Service Bulletin

Subject: Sotto Wash Mode Changed UG--20/30/40/50/65/80 MODELS

Sotto Ice Machines:

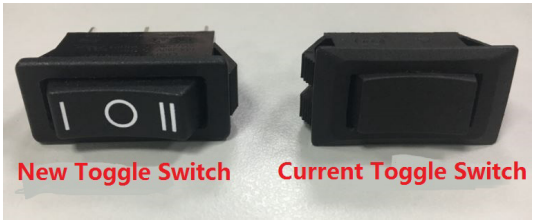
The control board and toggle switch on Sotto Ice machines has been changed. We believe this change will make our ice machines easier to operation, easier to service and more reliable.

1.The new toggle switch has a spring on the “WASH” position, which will prevents accidentally activating an undesired wash cycle.

2.The new toggle switch can only be used with the new control board.

3.Because of different sizes, the current toggle switch and new toggle switch are NOT interchangeable.
